SERVICE BULLETIN

N° **139-444**

REV. : C - June 28, 2018

ATA 78 - EXHAUST DUCTS AND REAR FIREWALL RETROMOD

Figure 6

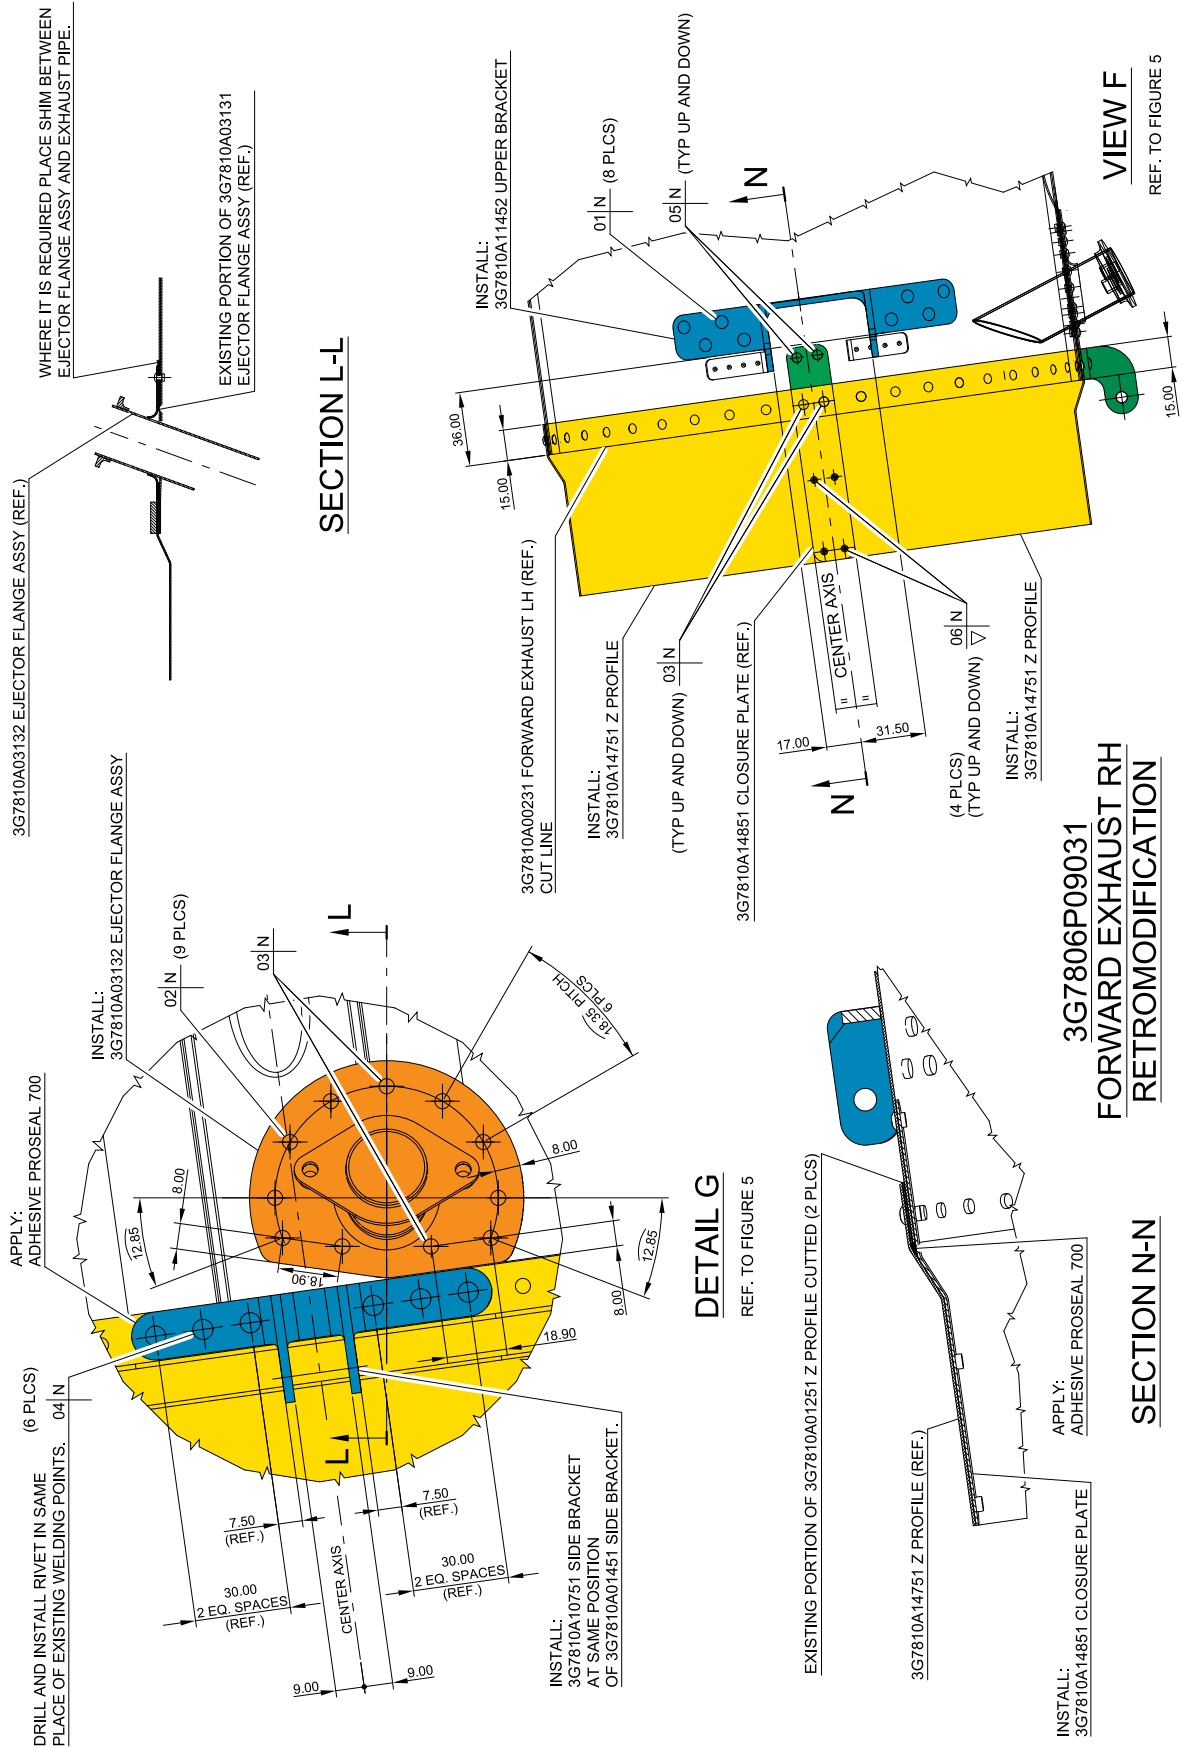
- 3.9 With reference to Figure 6 view F and section N-N, temporarily locate n°2 Z profiles P/N 3G7810A14751 and n°2 closure plates P/N 3G7810A14851. Countermark on Z profiles the positions of n°59 rivet holes and the positions of n°4 rivet holes in the forward exhaust.

- 3.12 With reference to Figure 6 view F, drill on the forward exhaust n°4 holes $\varnothing 2.36 \div 2.62$, in the previously marked positions.
- 3.13 With reference to Figure 6 view F, install together n°2 Z profiles P/N 3G7810A14751 and n°2 closure plates P/N 3G7810A14851 by means of n°8 rivets P/N NAS1097U3-3. Seal any openings by means of Proseal 700.

- 3.15 With reference to Figure 6 detail G, temporarily locate side bracket P/N 3G7810A10751 and countermark the positions n°6 rivet holes.
- 3.16 With reference to Figure 6 detail G, drill on the side bracket n°6 rivet holes $\varnothing 3.18 \div 3.43$ in the previously marked positions.
- 3.17 With reference to Figure 6 detail G, install side bracket P/N 3G7810A10751 by means of n°6 rivets P/N MS20615-4M6. Seal all around the side bracket by means of Proseal 700.

- 3.18 With reference to Figure 6 detail G and section L-L, temporarily locate ejector flange assembly P/N 3G7810A03132 and countermark position of n°11 rivet holes at positions shown.
 - 3.19 With reference to Figure 6 detail G, drill n°11 rivet holes $\varnothing 2.36 \div 2.62$ in previously marked position.
 - 3.20 With reference to Figure 6 detail G, install ejector flange assy P/N 3G7810A03132 by means of n°9 rivets P/N MS20615-3M3R and n°2 rivets P/N MS20615-3M4.
 - 3.21 With reference to Figure 6, mark P/N 3G7806P09031 in a visible area on the reworked forward exhaust RH, by means of an indelible pen.
4. Send the attached compliance form to the following mail box:

Figure 7

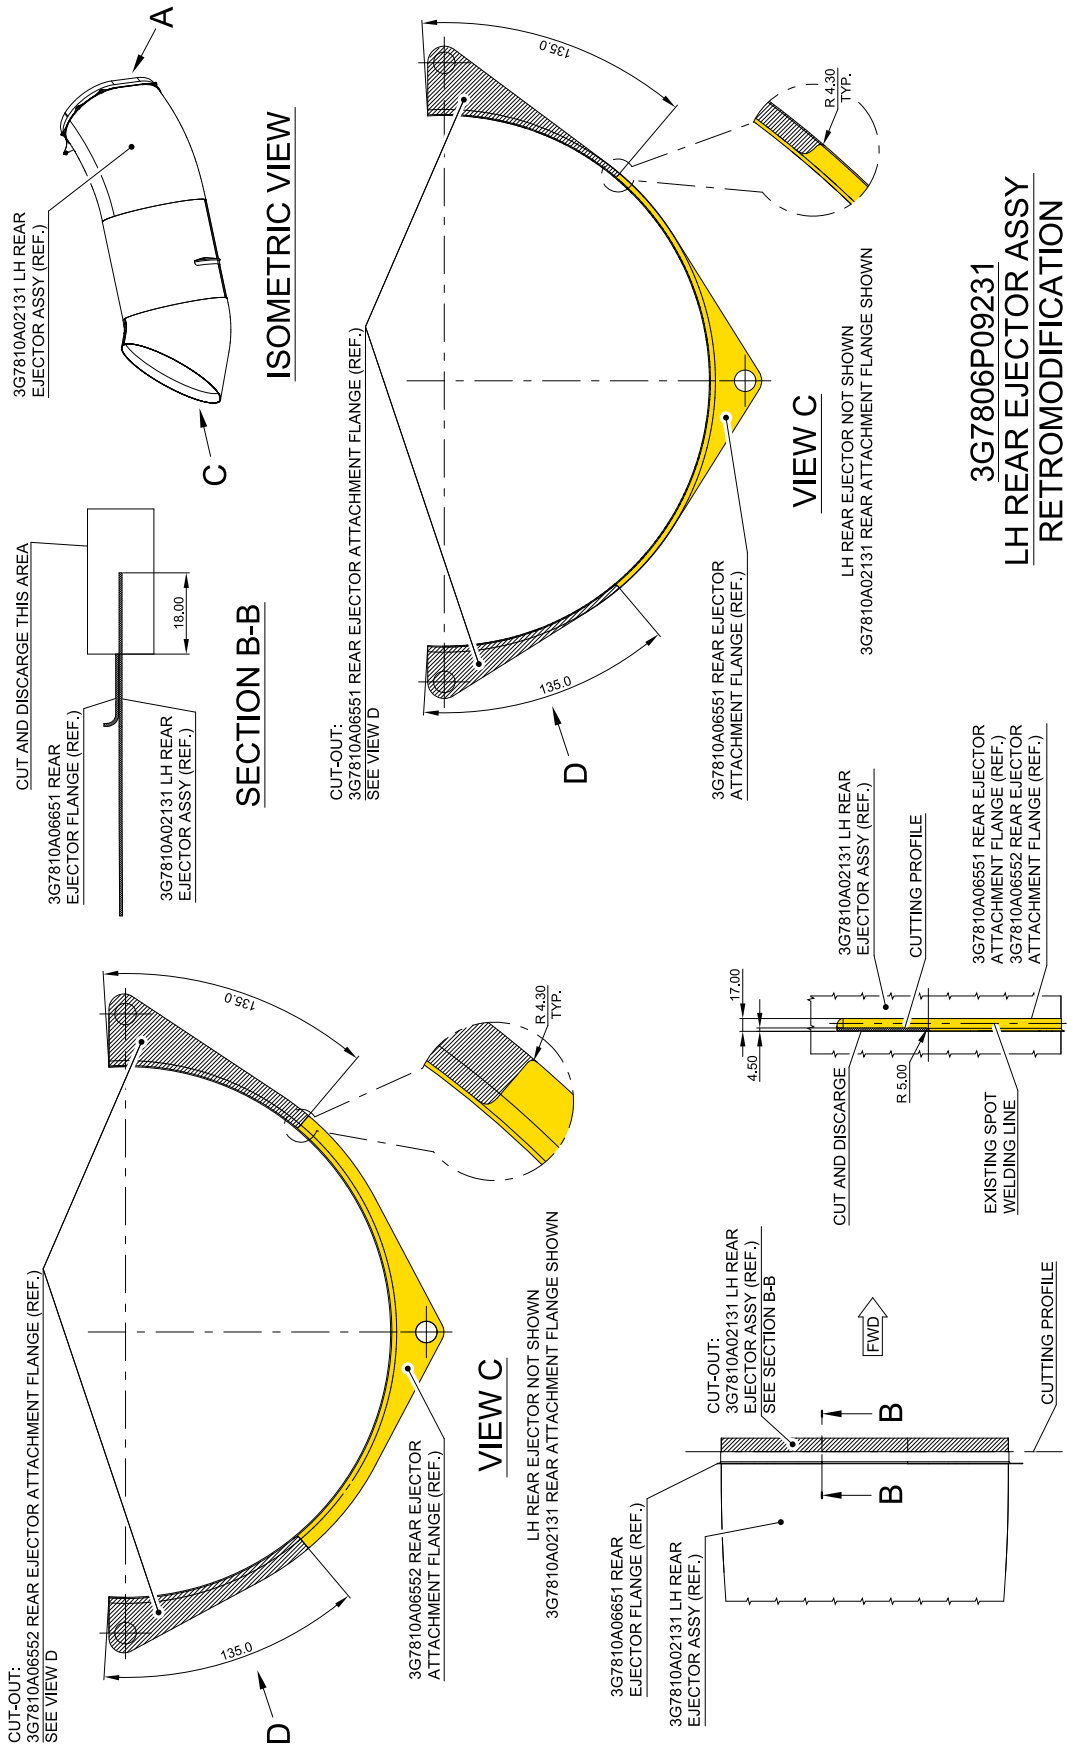
- 3.1 With reference to Figure 7 view A and section B-B, perform indicated cut out of LH rear ejector assy P/N 3G7810A02131.

- 3.2 With reference to Figure 7 view C and view D, perform cut out of rear ejector attachment flange P/N 3G7810A06552 or P/N 3G7810A06551 along the cutting profile shown.

- 3.3 With reference to 7 view C and view D, remove the portion of rear ejector attachment flange damaged.
- 3.4 With reference to Figure 8 and Figure 10, countermark the position of n°118 rivet holes on the LH rear ejector assy P/N 3G7810A02131 as shown in the figures.

Figure 8

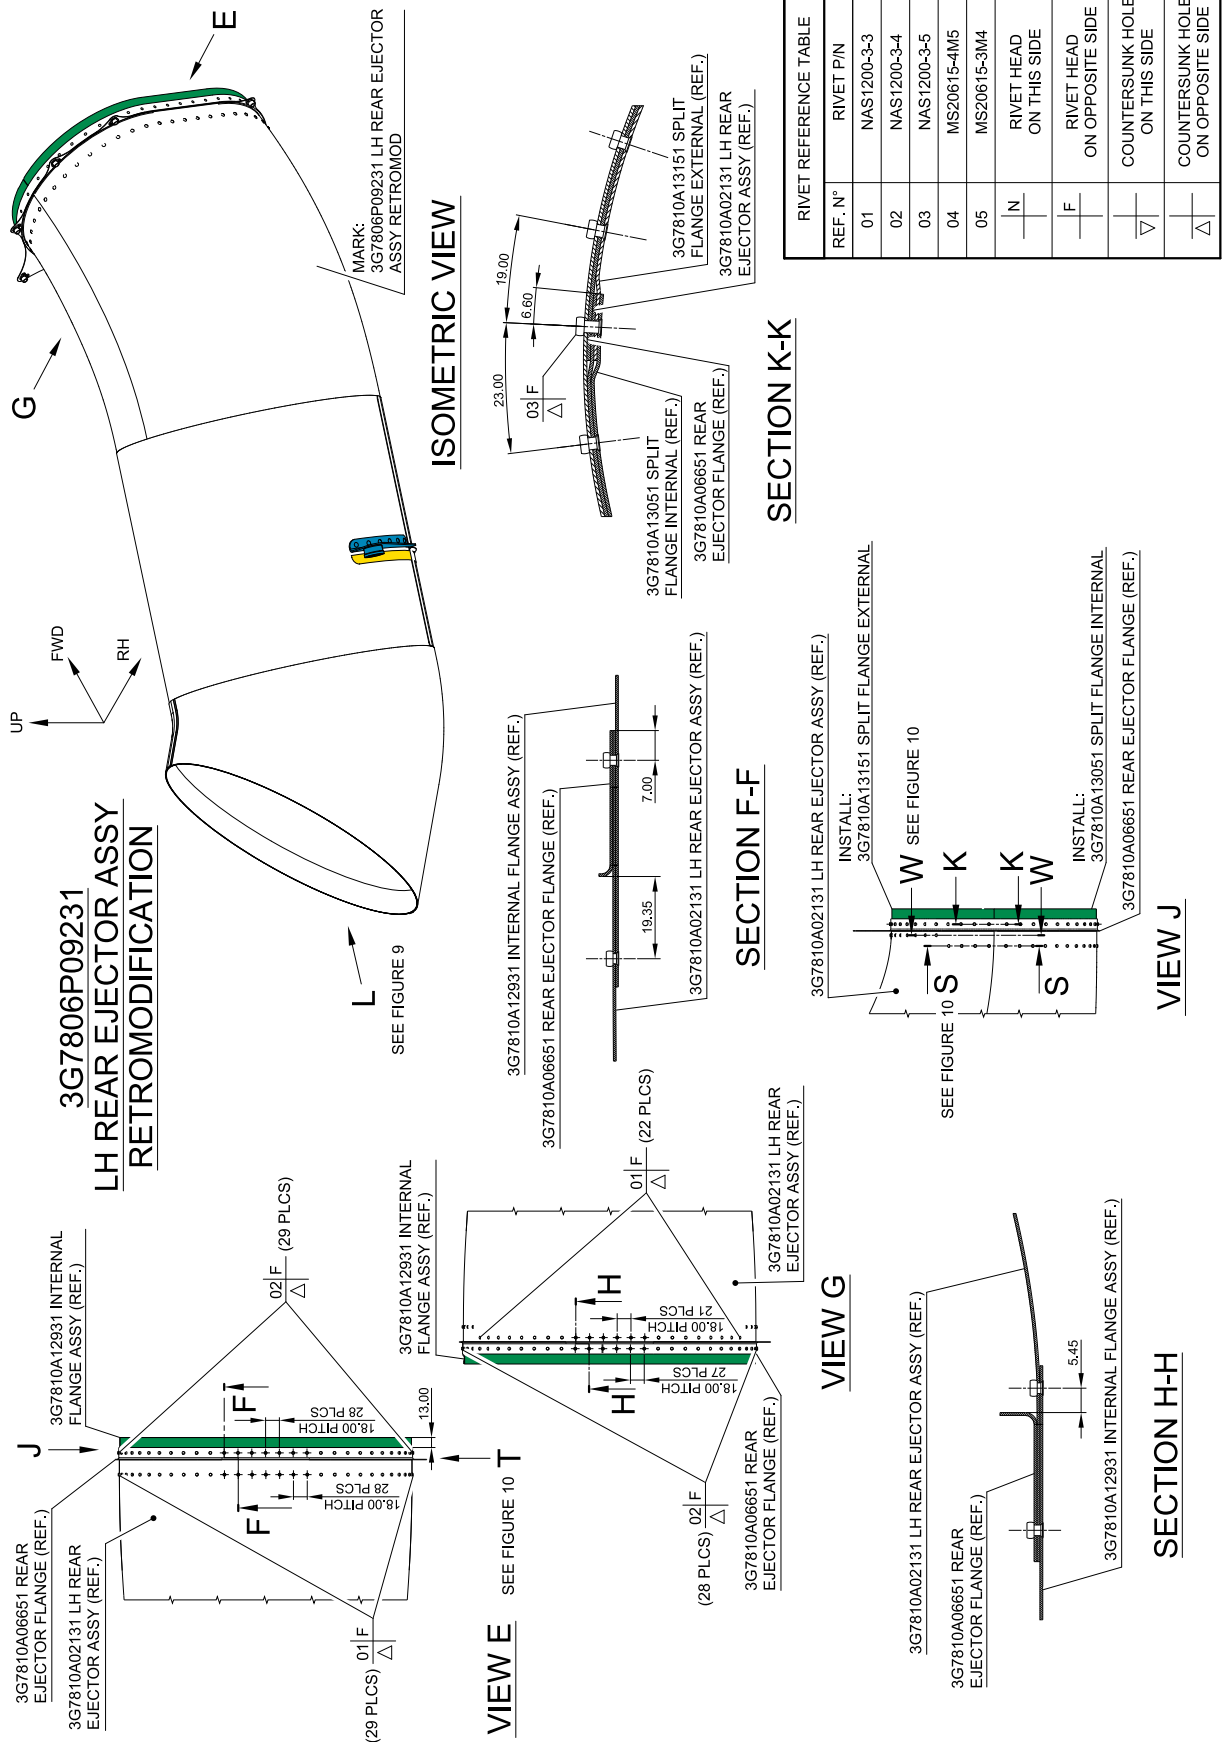
- 3.5 With reference to Figure 8 and Figure 10, drill n°118 rivet holes $\varnothing 2.36 \div 2.62$ through the LH rear ejector assy P/N 3G7810A02131, in previously marked positions.

- 3.6 With reference to Figure 8 and Figure 10, temporarily install n°1 split external flange P/N 3G7810A13151 and n°1 split internal flange P/N 3G7810A13051. Countermark the position of n°118 rivet holes on the two flanges.

- 3.7 With reference to Figure 8 and Figure 10, drill n°118 rivet holes $\varnothing 2.36 \div 2.62$ on the two flanges, in previously marked positions.

- 3.8 With reference to Figure 8 and Figure 10, install together n°1 split external flange P/N 3G7810A13151 and n°1 split internal flange P/N3G7810A13051, by means of n°57 rivets P/N NAS1200-3-3, n°59 rivets P/N NAS1200-3-4 and n°2 rivets P/N NAS1200-3-5.

- 3.18 With reference to Figure 8, mark P/N 3G7806P09231 in a visible area on the reworked LH rear ejector assy, by means of an indelible pen.
4. With reference to Figure 37, if the rear exhaust aft attachment flange P/N 3G7810A06551 or P/N 3G7810A06552 has been subject to temporary repair procedure applied as part of dedicated in-service maintenance action, and if during the application of the retro-modification 3G7806P09231 the removal of such temporary repairs related hardware leaved unused rivet holes in the exhaust duct, perform the following procedure:

Figure 9

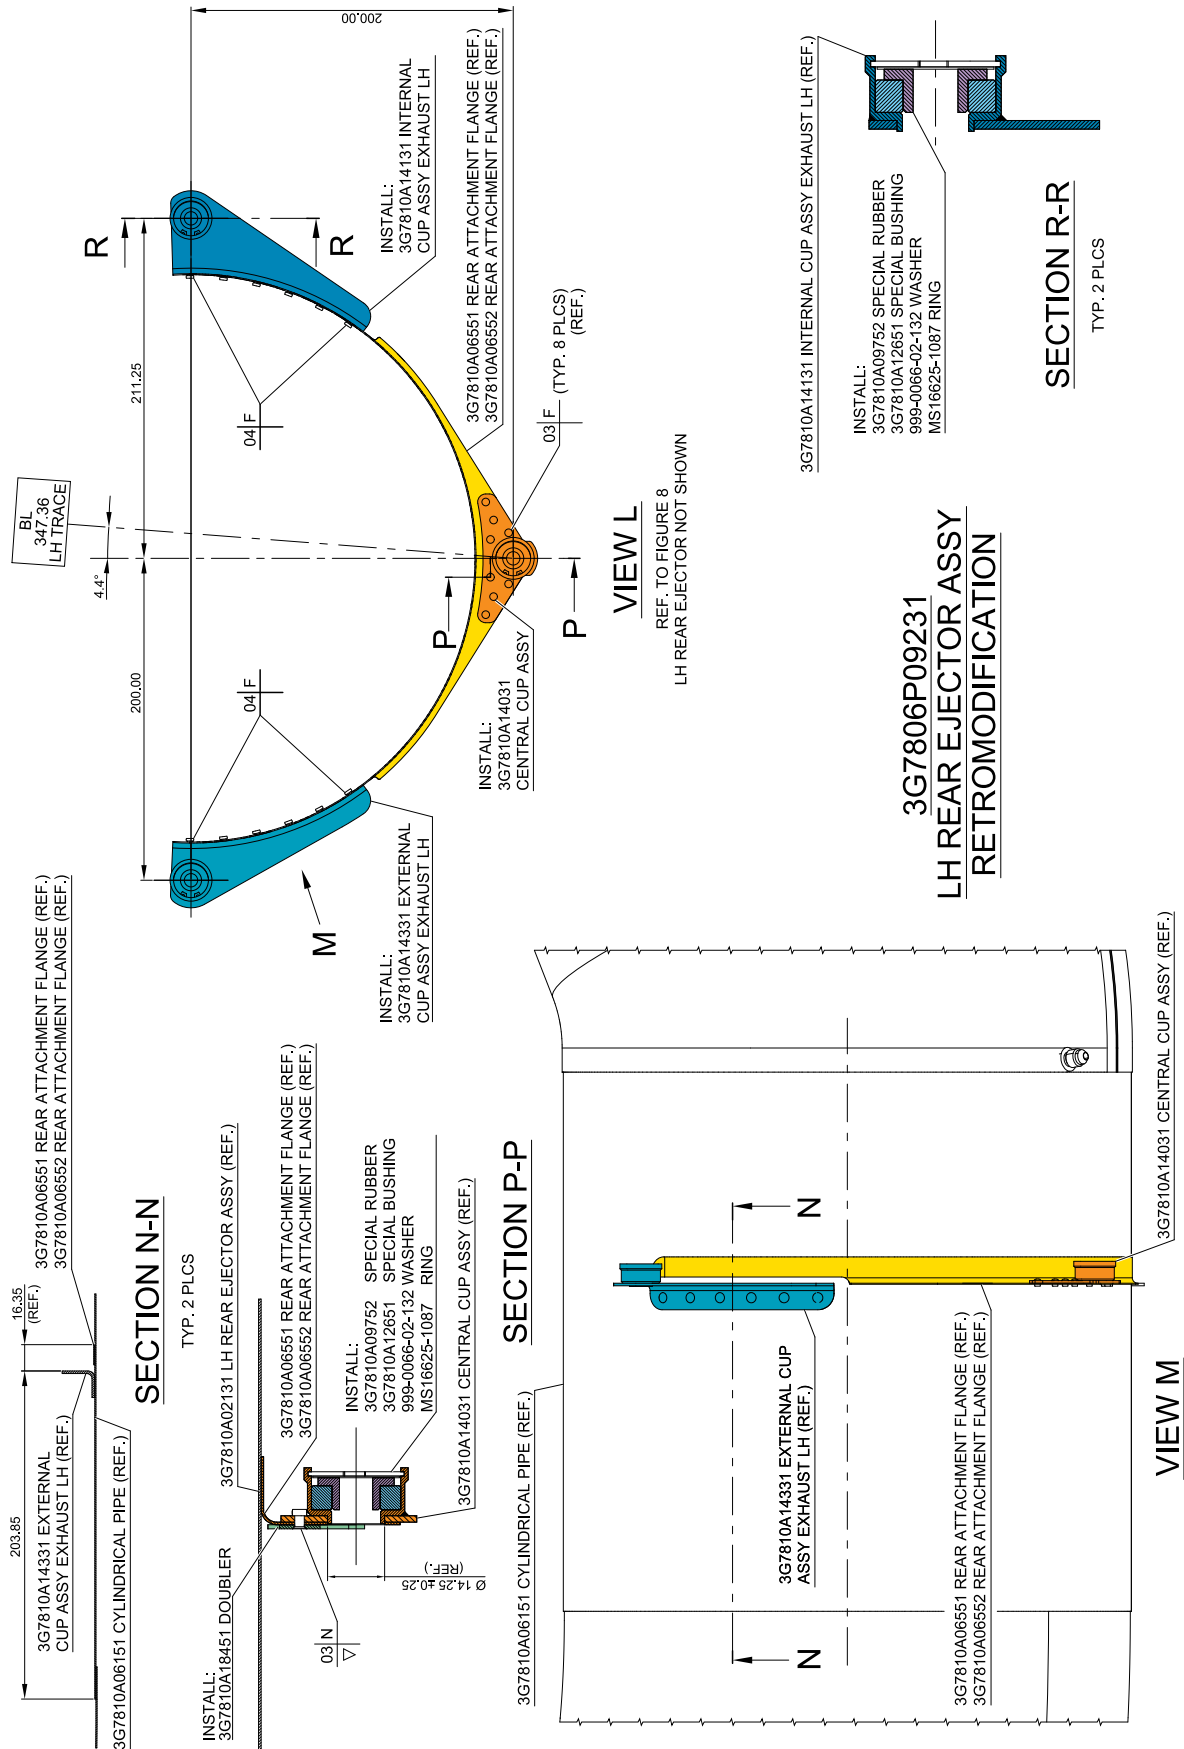
- 3.9 With reference to Figure 9 view L and section P-P, temporarily locate central cup assy P/N 3G7810A14031 and doubler P/N 3G7810A18451 and countermark position of n°8 rivet holes in the rear attachment flange.
- 3.10 With reference to Figure 9 view L, drill n°8 rivet holes $\varnothing 2.36 \div 2.62$ in previously marked position.

- 3.11 With reference to Figure 9 view L and section P-P, install central cup assy P/N 3G7810A14031 and doubler P/N 3G7810A18451 by means of n°8 rivets P/N NAS1200-3-5.
- 3.12 With reference to Figures 38 and 39, perform the rear left exhaust flange repair P/N 3G7810R00911 as described in the following procedure:
- 3.12.1 With reference to Figure 38, remove the indicated area.
- 3.12.2 With reference to Figure 39, install the central flange LH assy P/N 3G7810A18731 by means of n°7 rivets P/N MS20615-4M4R.

- 3.13 With reference to Figure 9 Section P-P, install in the central cup assy one special rubber P/N 3G7810A09752, one special bushing P/N 3G7810A12651, one washer P/N 999-0066-02-132 and one ring P/N MS16625-1087.
- 3.14 With reference to Figure 9 view L and section N-N, temporarily locate external cup assy exhaust LH P/N 3G7810A14331 and internal cup assy exhaust LH P/N 3G7810A14131 and countermark position of n°12 rivet holes in the LH rear ejector.

- 3.15 With reference to Figure 9 view L, drill n°12 rivet holes $\varnothing 3.18 \div 3.43$ in previously marked position through LH rear ejector.
- 3.16 With reference to Figure 9 view L, install external cup assy exhaust LH P/N 3G7810A14331 and internal cup assy exhaust LH P/N 3G7810A14131, by means of n°12 rivets P/N MS20615-4M5.

- 3.17 With reference to Figure 9 section R-R, install in the external and internal cup assy exhaust LH and RH n°2 special rubbers P/N 3G7810A09752, n°2 special bushings P/N 3G7810A12651, n°2 washers P/N 999-0066-02-132 and n°2 rings P/N MS16625-1087.
